### **Sporadic Check Control Messages of the Driver Assistance System**

F32 (4 Series Coupe)

Produced from July 9, 2015 to August 12, 2015

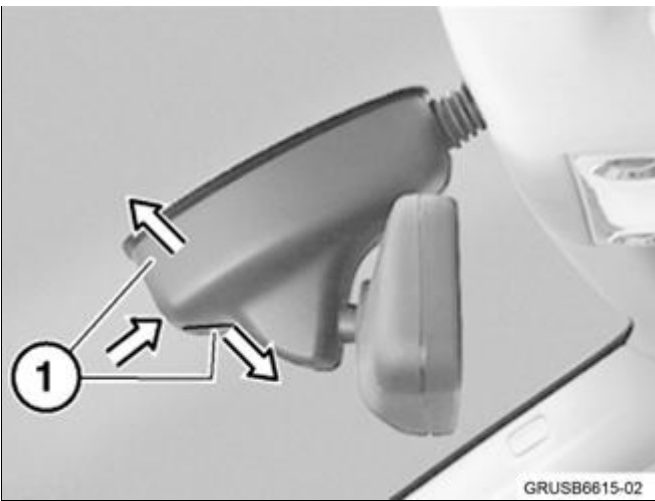
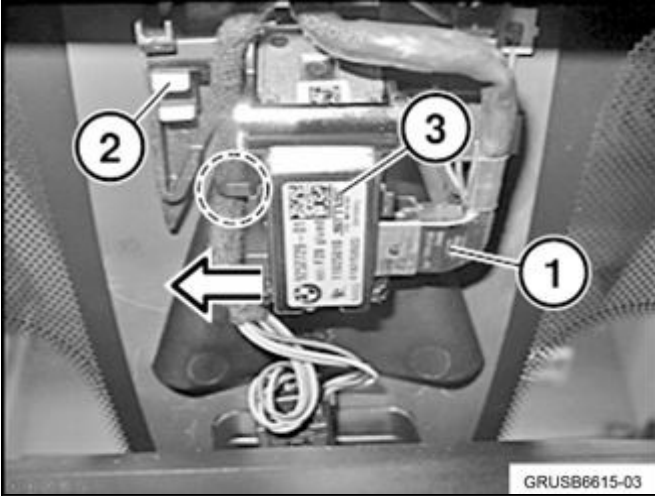
<p style="text-align: right;">GRUSB6615-02</p>	<p><b>Note: Latch mechanisms of two-part mirror base cover (1) must not be damaged.</b></p> <p>Remove the two-part mirror base cover (1) by pressing from below and separating.</p> <p>Slide out two-part mirror base cover (1) and remove.</p>
 <p style="text-align: right;">GRUSB6615-03</p>	<p>The date code label is shown on the bottom of the KAFAS camera (3).</p>

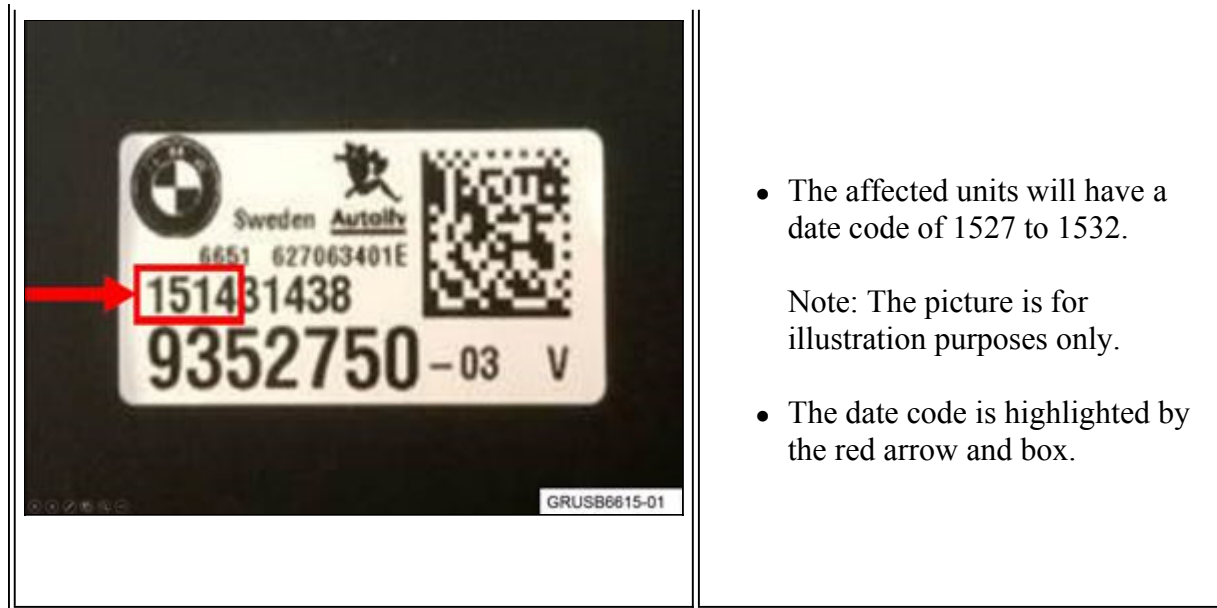
- The affected units will have a date code of 1527 to 1532.

- The date code is highlighted by the red arrow and box.

Install the KAFAS camera with a date code of 1533 or higher

3. Replace the KAFAS camera if the date code is between 1527 to 1532.
4. Refer to Repair Instructions REP 66 51 030 – remove and install/replace KAFAS camera
